INSTRUCTIONS FOR REPLACING OIL SEAL IN SCRAMBLER PINION CASTING ASSEMBLY

UNIT POLE MODIFICATION

MODIFICATION OF SCRAMBLER TOP SWEEPS

SAFETY BULLETIN

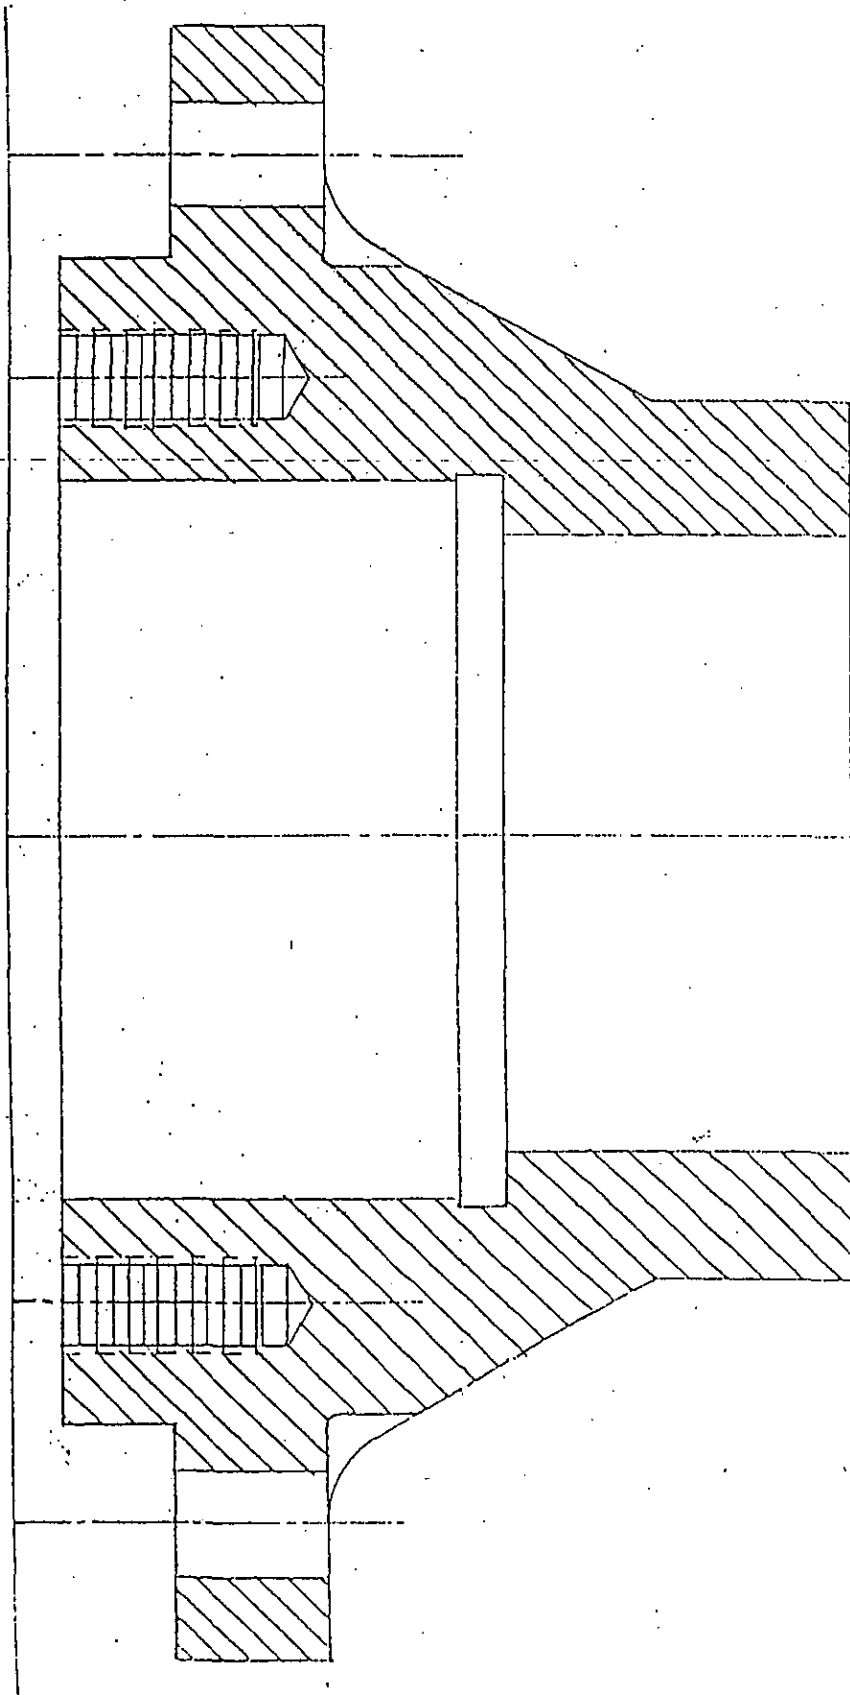
The original seal used in the pinion casting assembly was a Chicago Rawhide "Perfect" oil seal Part No. 15245. The manufacturer discontinued that seal, and we could not find an interchangeable replacement from any other manufacturer. The closest seal in size was a Chicago Rawhide Part No. 15250. The original seal had an outside diameter of 3.066", and the replacement had an outside diameter of 3.130".

Therefore, to replace the seal it is necessary that the pinion casting assembly be disassembled and the casting re-bored to $3.125" \pm .0015"$.

1. Remove the pinion casting assembly from the Scrambler, by taking out the six cap screws that secure it to the stationary base gear pot cover plate.
2. Remove the chain sprocket from the end of the shaft.

3. Remove the locking wire. It is 19 gage, dead soft iron wire, two feet long. When the time comes to replace it, thread the wire through the bolt heads so that loosening of the bolt will cause the wire to tighten, and then twist the ends of the wire together tightly with four turns to keep it from unwinding.

4. Remove the six cap screws that were wired together. This releases the flat ring bearing retainer so that it can be removed from the casting along with the bevel pinion gear, bearing, hardened washer, lock washer, and adjusting nut. All of these parts come out together and do not need to be disassembled.

5. The snap ring stays in the casting and is not to be removed.
6. The casting can then be re-bored to $3.125" \pm .0015"$.
7. Then, re-assemble all the parts, and install it on the Scrambler

The pinion casting was originally machined by gripping the casting at the small end in a three-jaw chuck. All the turned faces on the casting were finished from that one setup except for the facing off of the small end, and that was done after the rest of the machining was completed by reversing the casting in the chuck and gripping it on the large diameter locating shoulder. To re-bore the casting to the new larger diameter, grip the casting in a three-jaw chuck on the large diameter as if you were going to face off the small end. Check the original seal diameter with a dial indicator to be sure that the bore is running true before re-boring to $3.125" \pm .0015"$.

TYPICAL MOUNTING DETAIL DOUBLE TAB BUSHING

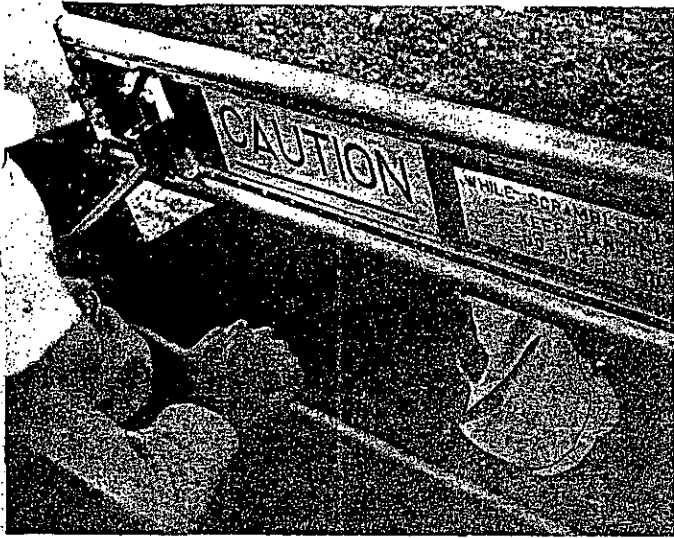
- * TYPICAL INSTALLATION LOCATIONS ARE NOTED IN RED ON ENCLOSED SCRAMBLER INSPECTION LIST.

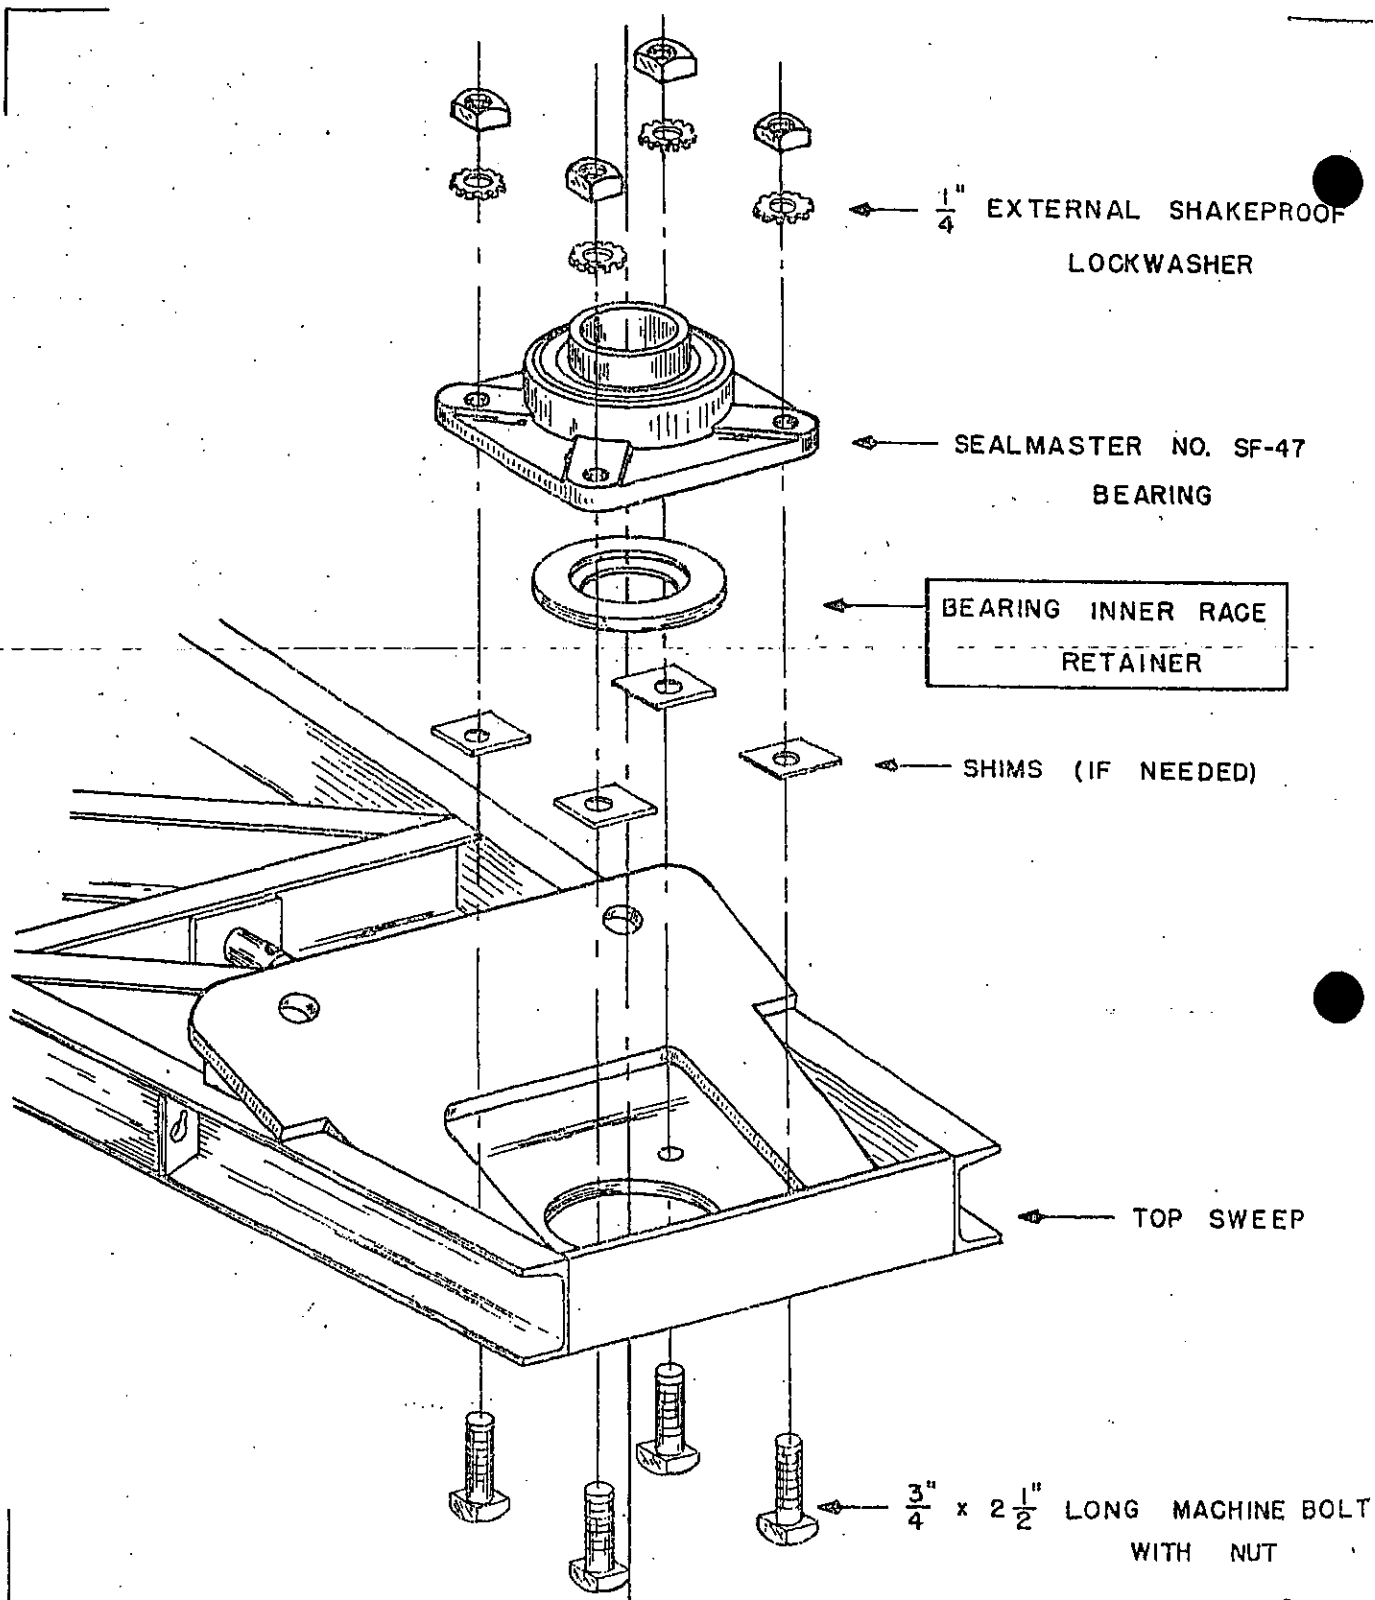
4 REINFORCEMENTS GO ON EACH UNIT POLE.

FOR CLARITY, ONLY TWO ARE SHOWN IN THE SKETCH.

KEEP THE REINFORCEMENTS IN LINE WITH EXISTING, GUSSETS, STRAIGHT UP THE POLE.

TACK ALL FOUR IN PLACE, KEEP WELDING BALANCED TO AVOID WARPING POLE. REMOVE CHAIN FROM COUPLING AND TURN UNIT POLE FREQUENTLY TO MAKE SURE GEAR MESH IS EVEN.
